BULLETIN #6-133-MC

MAIN BOOM ROCKER SHAFT FOR ROUND-UP RIDES MANUFACTURED BY FRANK HUBERZ & CO., INC. AND KILINSKI MFG. CO.

BULLETIN: BU-135 MC

ANNUAL INSPECTION OF MAIN SPINDLE SHAFTS, ROCKER SHAFTS, CYLINDER ANCHOR SHAFTS

Figure 1

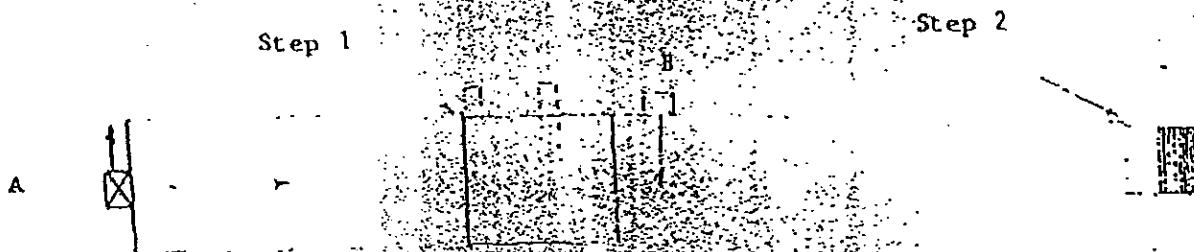
1. A 3/4" Diameter - 5 MHZ Transducer is recommended.
2. The search unit shall be placed on center of shaft area (A) and adjust second back reflection to 100%.
3. Move transducer toward edge of shaft (A) step 1 should appear to be approximately 25% of the total perimeter and adjust to the average.
4. The search unit shall be placed on an indication free area (B) of the shaft being tested and the first back reflection shall be set between 75 to 90% of full screen height.

Figure 2

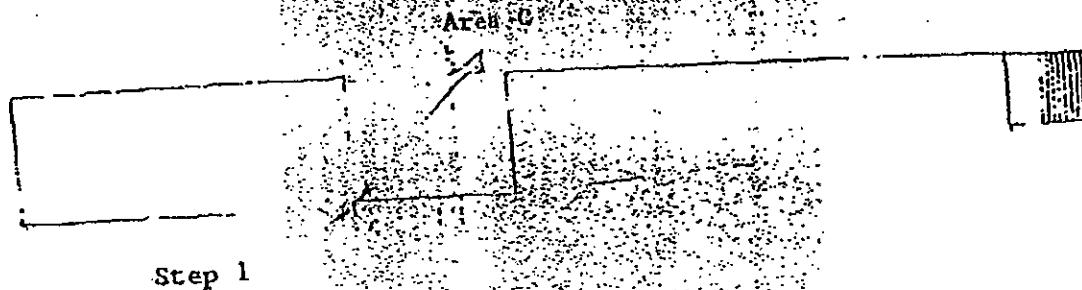
1. A 1/2" x 1/2" - 2.25 MHZ - 45° angle beam search unit is recommended.
2. The search unit shall be placed on an indication free area (C) and the instrument shall be adjusted to obtain a signal amplitude of 40 to 60% full screen height from the shaft step 1.

Figure 3

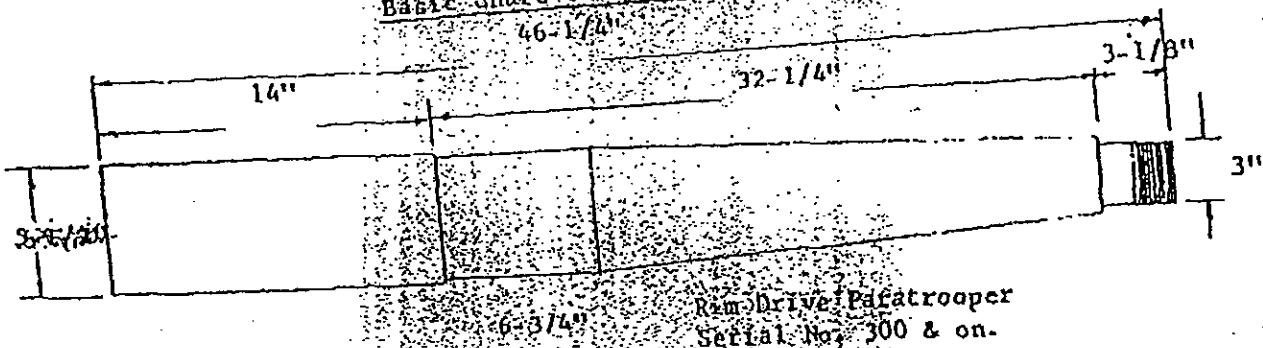
- A. Area (A) and (D) shall be scanned 100%.

- B. Area (B&C) shall be scanned 100%.

- A. Area (B&C) shall be scanned 100% in two axial directions 180° opposed.

Figure 1

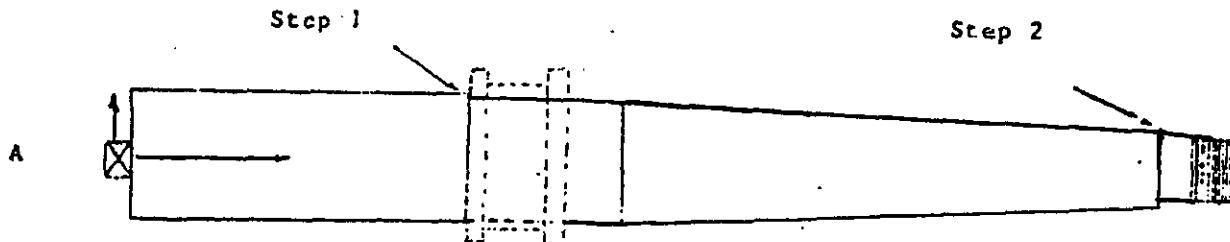
1. A 3/4" Diameter - 5 MHz Transducer is recommended.
2. The search unit shall be placed on center of shaft area (A) and adjust second back reflection to 100%.
3. Move transducer towards edge of shaft (A)
 - 3.1 Step 1 should appear to be approximately 25%.
 - 3.2 If not, scan the perimeter and adjust to the average.

Figure 2

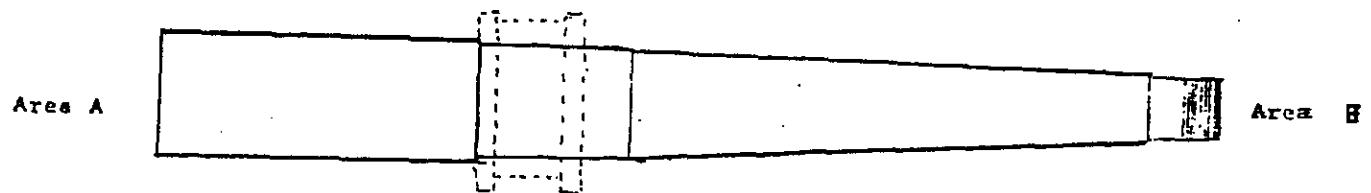
- A. After calibration per Figure 1, areas (A) and (B) shall be scanned 100%.

MAN-CO. MFG. INC.	
P.O. BOX 13114 SALEM, OR 97302	
MAIN BOOM ROCKER SHAFT	
DATE 5-14-04	SHAFT DIMENSIONS
DRAWN BY M.O.Z	PREVIOUS TO
SCALE —	SHAFTS WITH
NO. SHRINK COLLARS

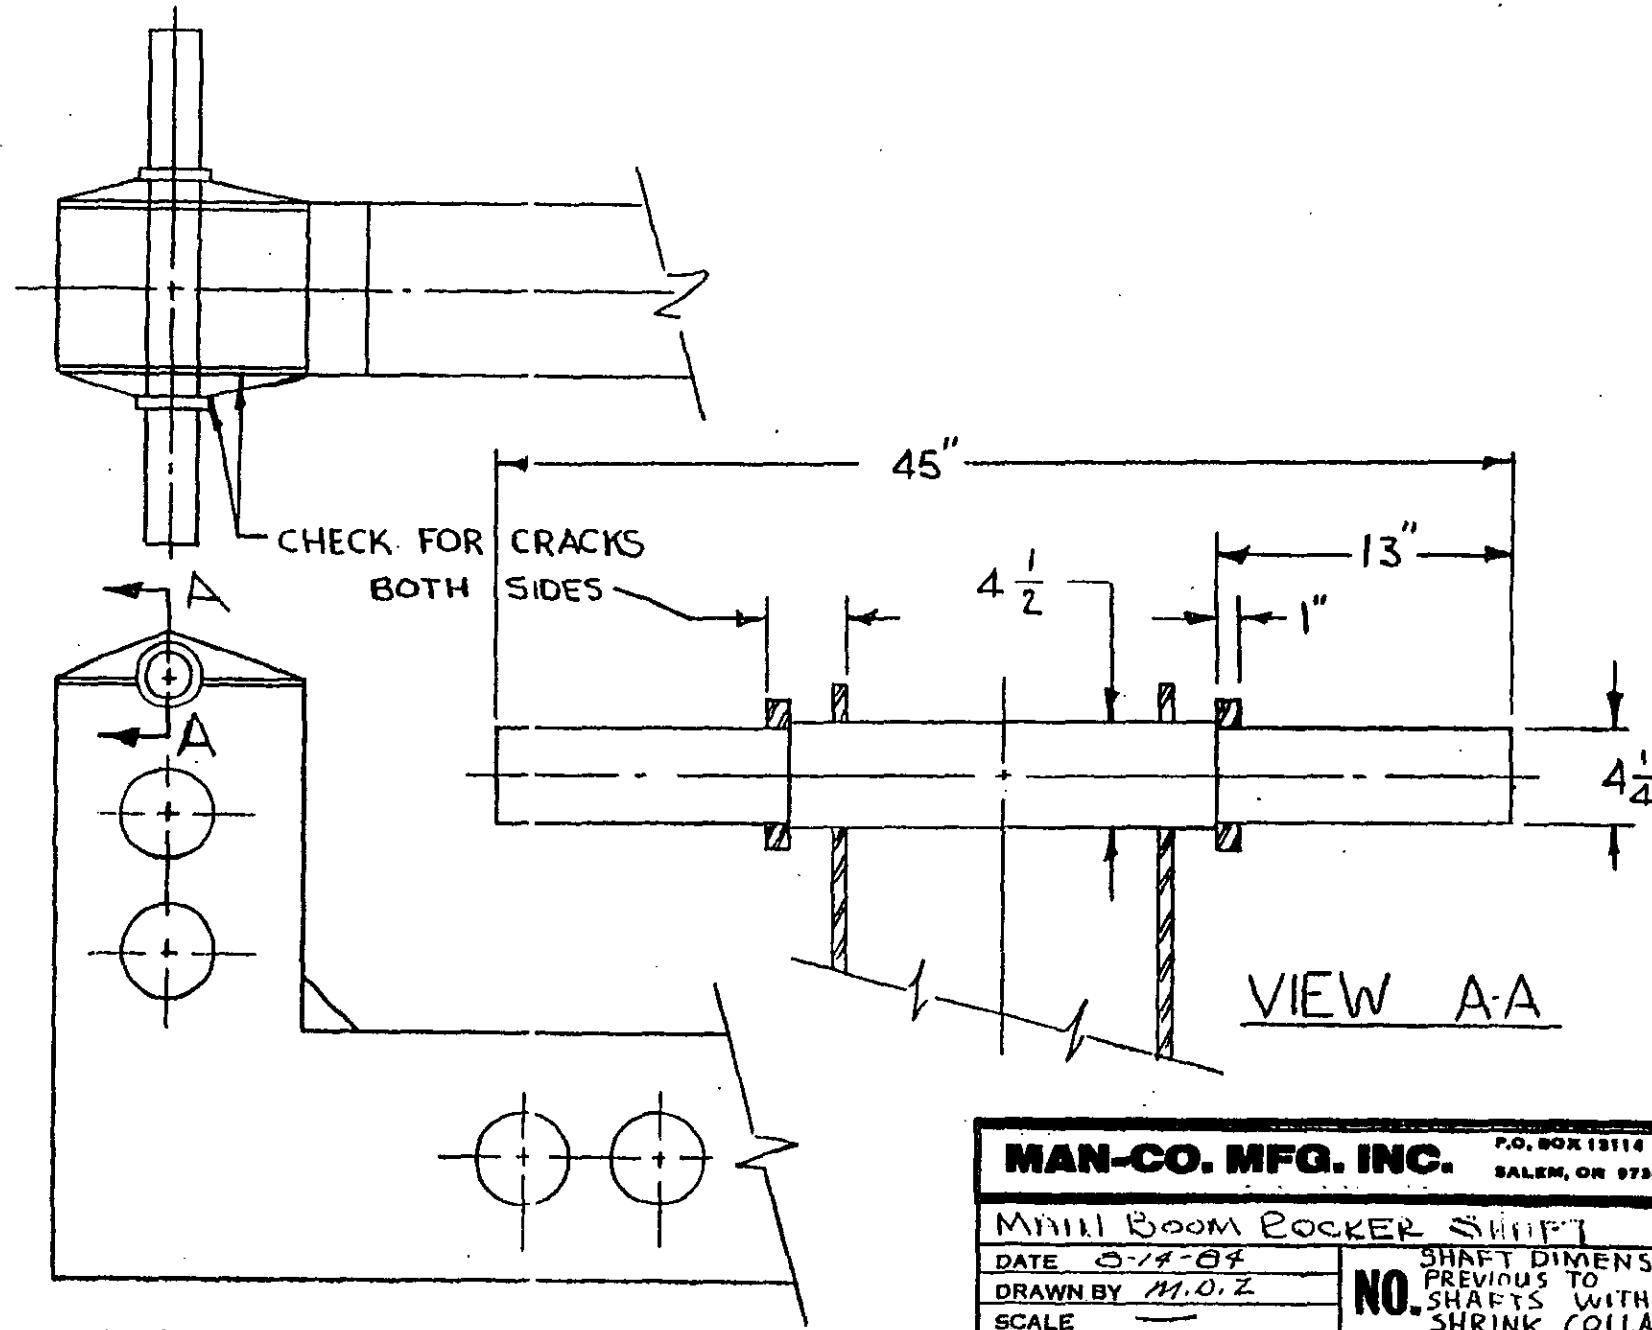
If you own a Round-Up, we strongly urge that you immediately inspect the main boom rocker shaft and the cylinder anchor shaft for cracks using Ultrasonic test. The test must be done by someone qualified to Level 2 ultrasonic testing. It is not necessary to disassemble the ride to perform the test on the main boom rocker shaft, or the cylinder anchor shaft.

This test was performed on a Round-Up at Man-Co Mfg., Inc. by an independent testing lab. Using a 2.5 MHz transducer on the end of the shaft. The instrumentation was set up to produce a strong reflection from the opposite end of the shaft and calibrated so that the shoulder on the far end of the shaft registered approximately 15-20% of full scale. This would cause a crack at or near the closer shoulder to register significantly. The test was repeated at the other end of the shaft. A sketch of the shaft is on Sheet 2.

If cracks are found in the shaft, it SHALL BE replaced immediately. Replacement shafts of the latest design may be purchased from Man-Co Mfg., Inc.

MAN-CO. MFG. INC.		P.O. BOX 12514 SALEM, OR 97303
CYL. ANCHOR SHAFT		
DATE	8-14-84	
DRAWN BY	M.W.Z	
SCALE	—	
NO.		SHAFT DIMENSIONS PREVIOUS TO SHAFTS WITH SHRINK COLLARS

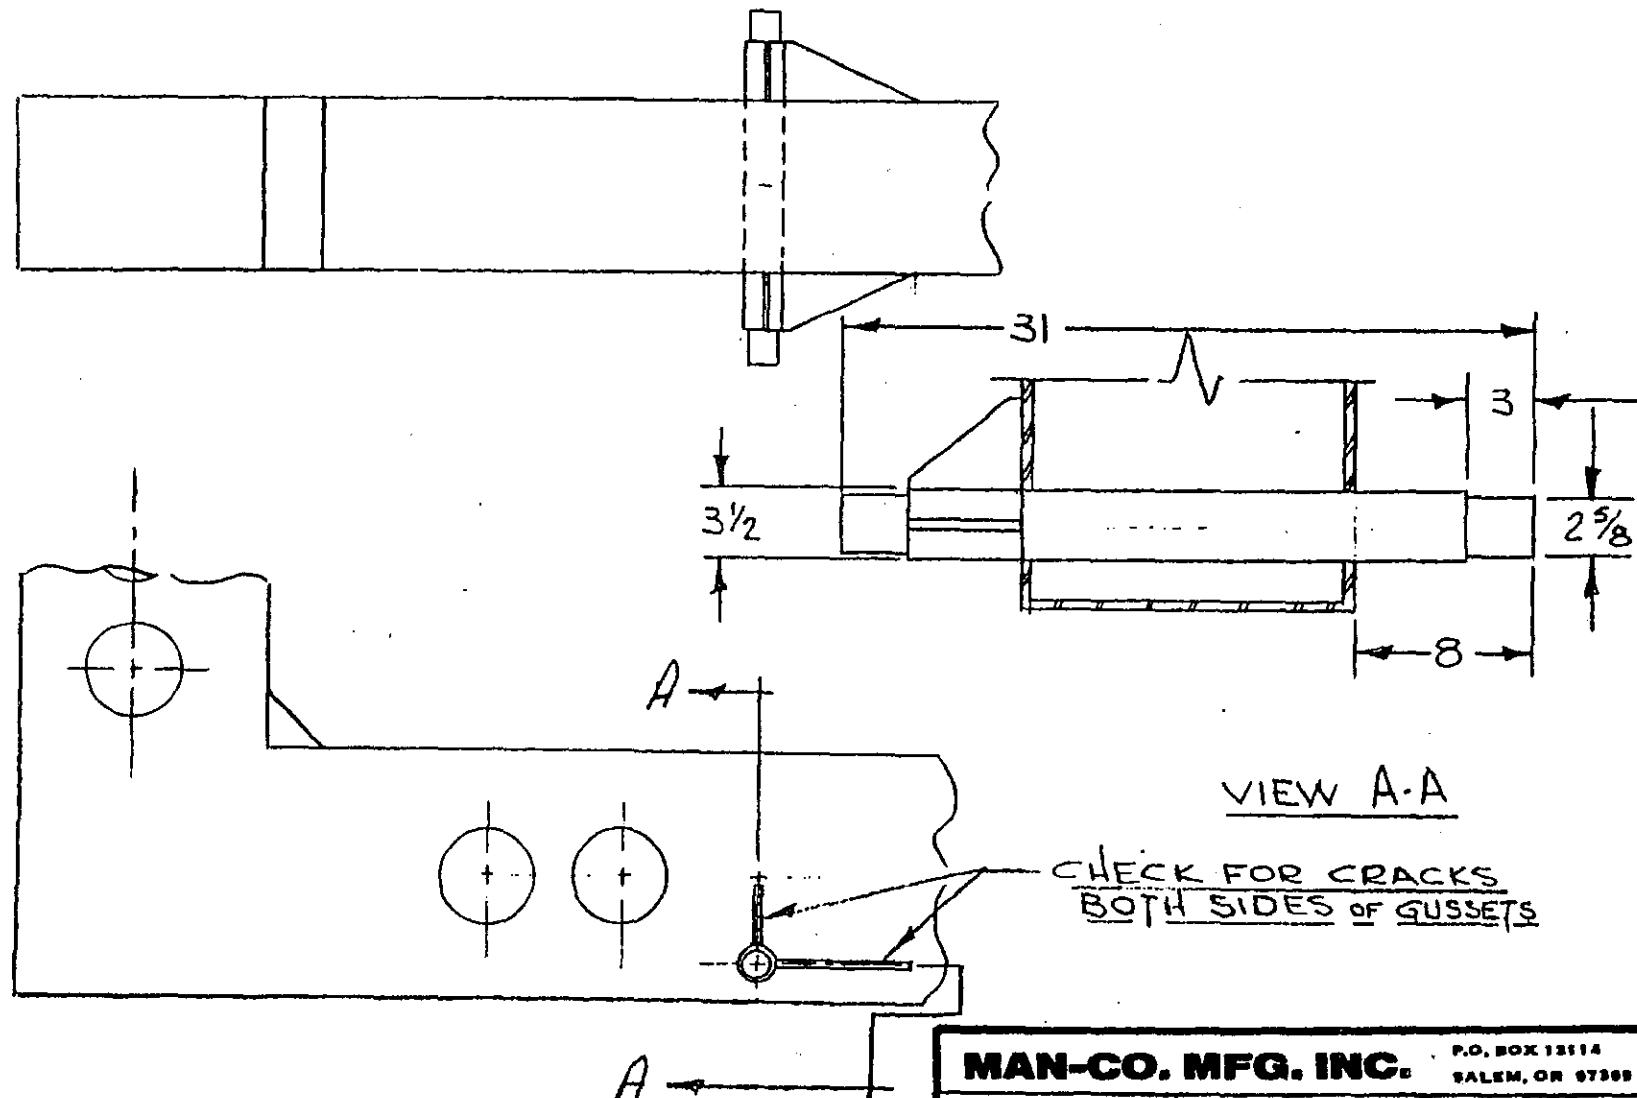
1. Rocker shaft - see Dwg. BU-133MC sht. 2 of 3
2. Cylinder Anchor shaft - see Dwg. BU-133MC sht. 3 of 3
3. Spindle shaft (every two (2) years)
